BOARD ACTION REPORT – APPEALABLE ITEM

Project Name: Pierre Delray I

SITE PLAN REVIEW AND APPEARANCE BOARD

File No.: 2019-256-SPF-SPR-CLIII

BIKE RACK
COMMENT #30

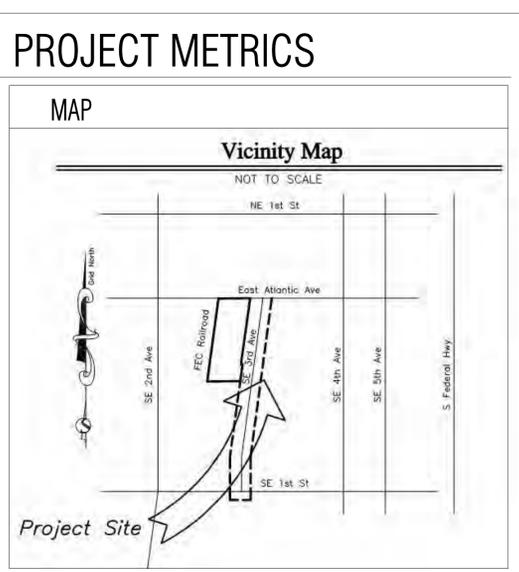
Pursuant to LDR Section 4.4.13(1)(4), Table 4.4.13 (M), Bicycle Parking Requirement, the minimum number of bicycle parking spaces for retail uses are 1 space per 1,000 sq. ft. and for Professional Offices 1 space per 2,000 sq. ft. The proposed building is 14,357 sq. ft. The gross square footage is composed of 2,771 sq. ft. of retail space, and 11,586 sq. ft. of business office space. As such, the retail square footage requires 3 spaces (2,771 sq. ft./1,000 sq. ft.) and the business office square footage requires 6 spaces (11,586 sq. ft. / 2,000 sq. ft.). As a result, the project is required to provide 9 bicycle parking spaces. Please provide bicycle parking racks that can accommodate 9 bicycles. You can put the bicycle rack in the curb zone, but the rack has to be perpendicular to Atlantic Avenue so that the bicycles do not stick out into the pedestrian clear zone.

5 BIKE RACKS ARE PROVIDED TO PROVIDE A TOTAL OF 10 BICYCLE SPACES. RACKS ARE PERPENDICULAR TO STREET.

1 PHOTOMETRIC PLAN
A14a Scale: 1/8" = 1'-0"

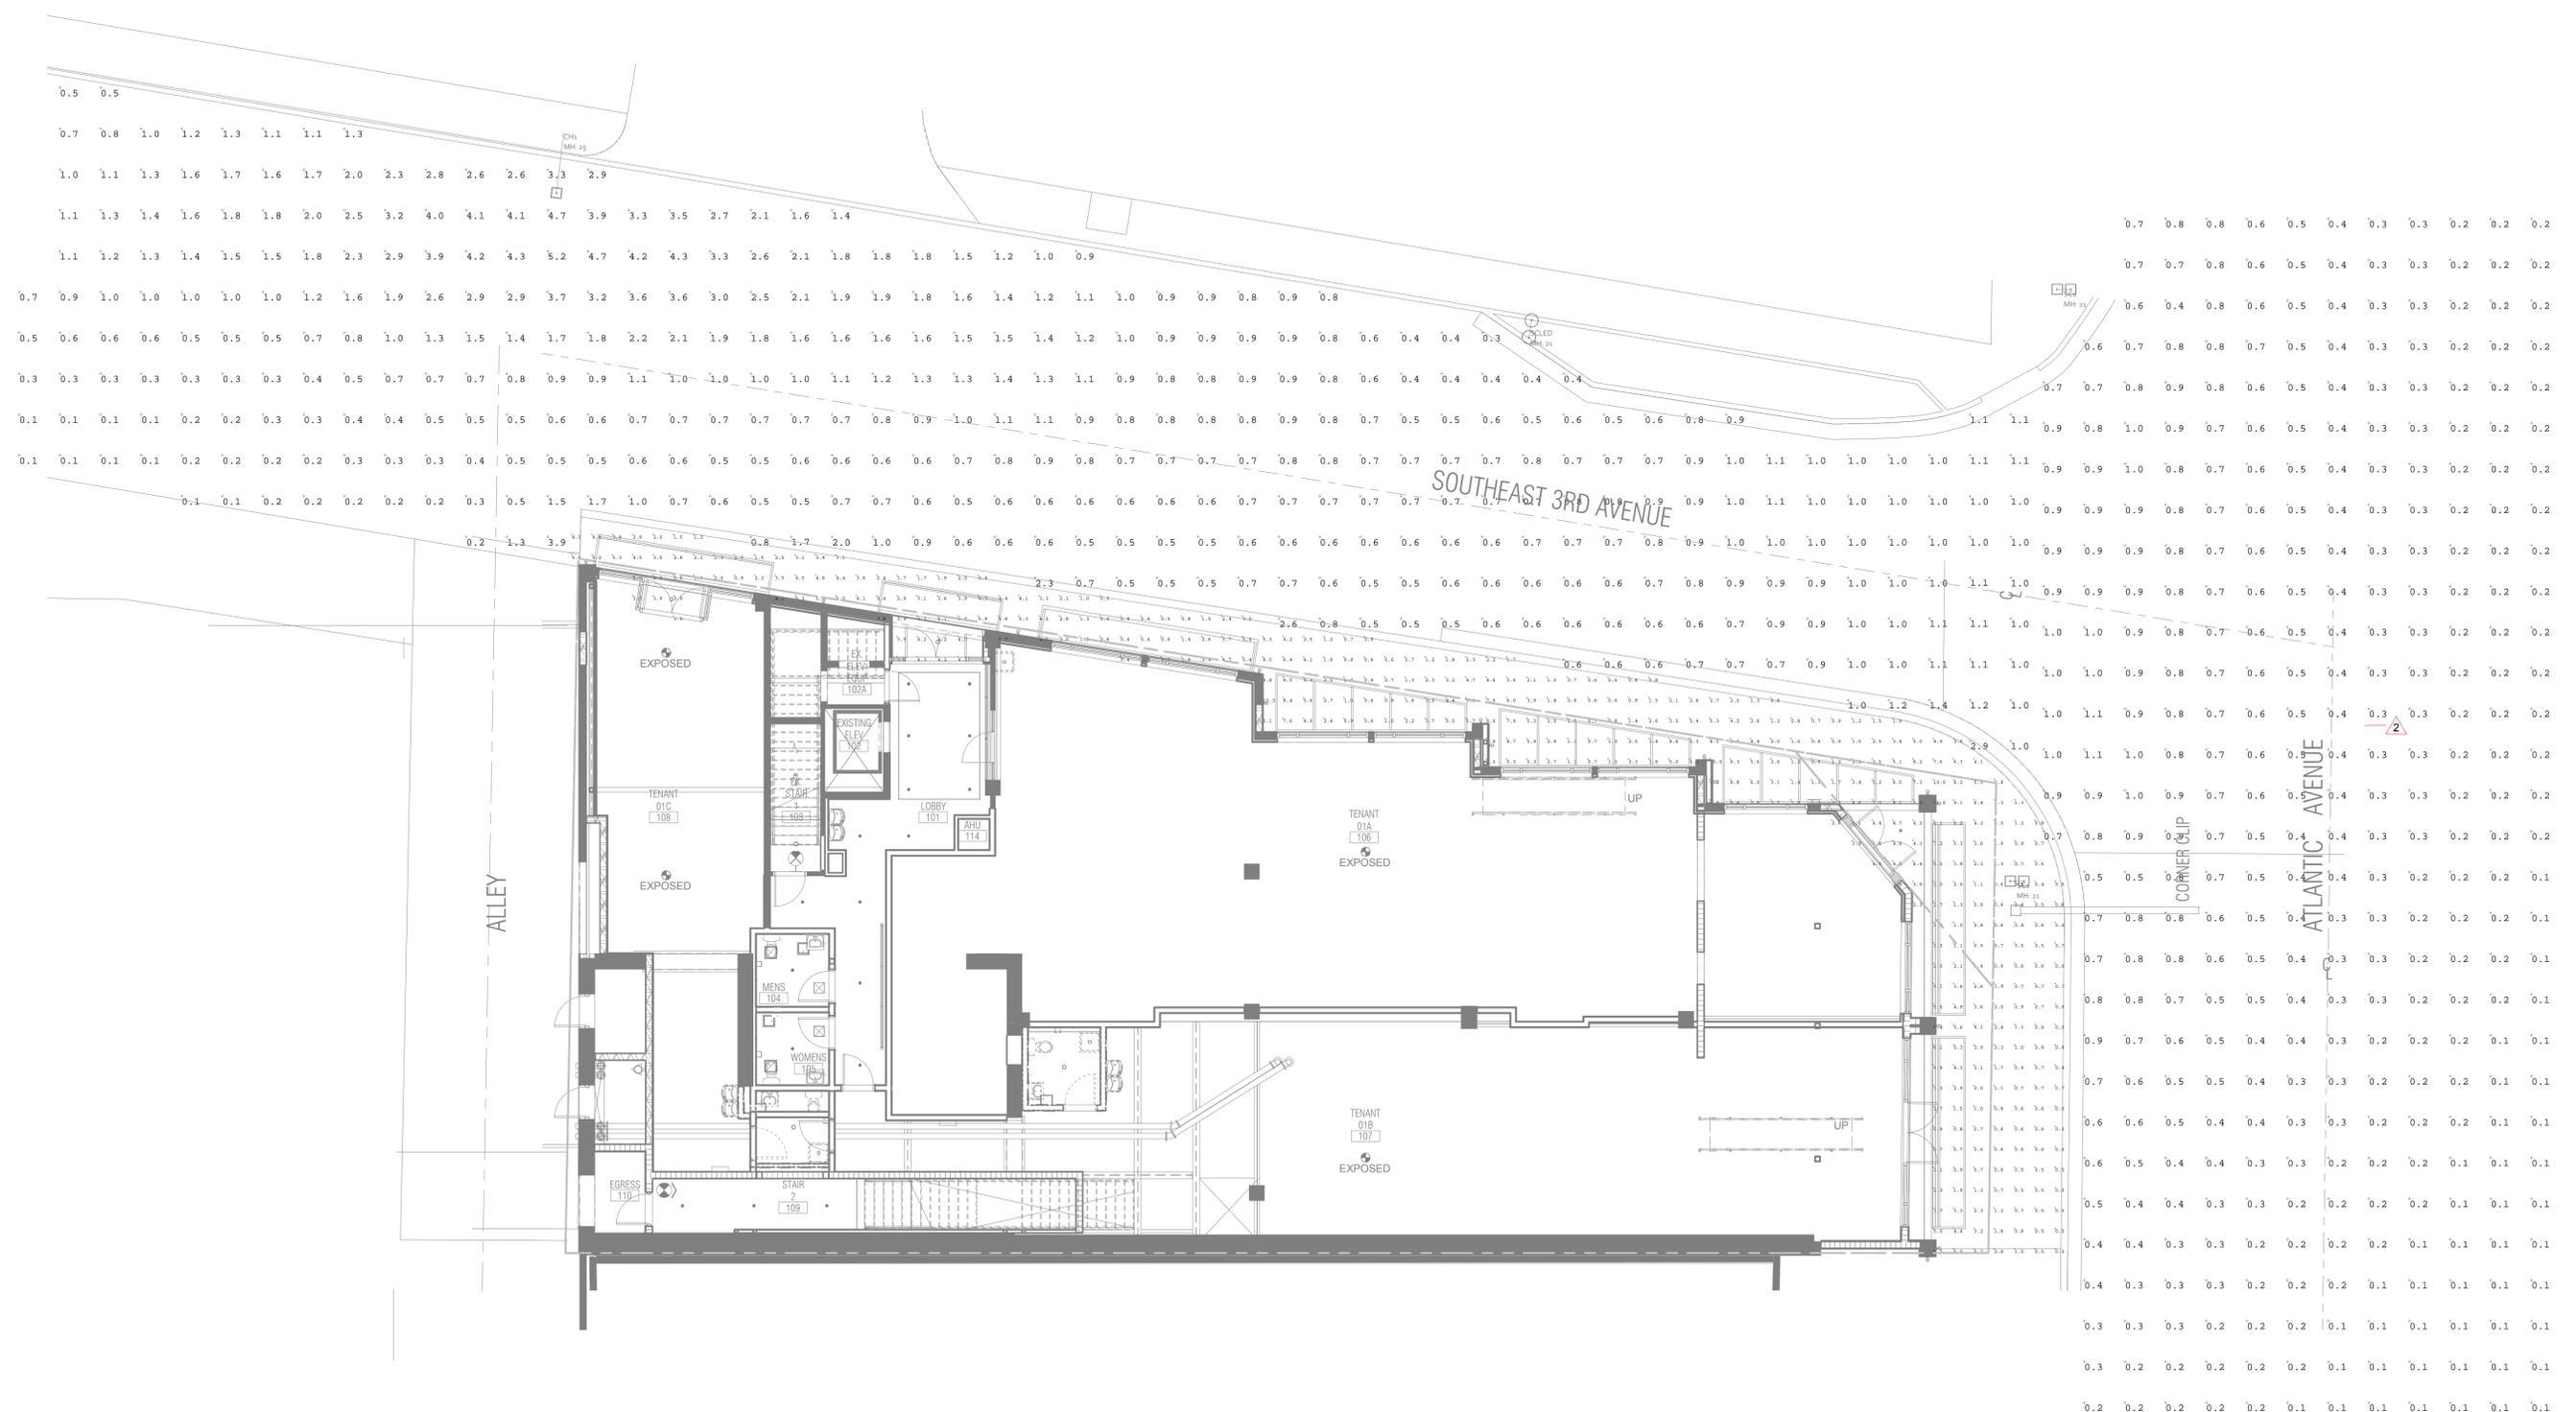
- The photometric plan sheet A14a provided shows illumination to the center line of SE 3rd Avenue and Atlantic Avenue. The light levels provided exceed the minimum light levels required for the building entrances along SE 3rd Avenue in order to provide illumination along SE 3rd Avenue. Lighting is required along SE 3rd Avenue because there are currently no streetlights along the east street adjacent to the building. The existing sidewalk along SE 3rd Avenue adjacent to the subject site is approximately 4.5’ and cannot accommodate streetlights, so the plans propose wall mounted fixtures to light the building entrances and to illuminate the ROW. The light levels along SE 3rd Avenue were increased higher than the minimum required in order to light the portion of the corridor. A note has been added to the staff report requiring that sheet A4 be updated prior to site plan certification to show the City Standard “Acorn” double light pole located across the SE 3rd Avenue be provided as part of the scope of work for Pierre Delray 1.
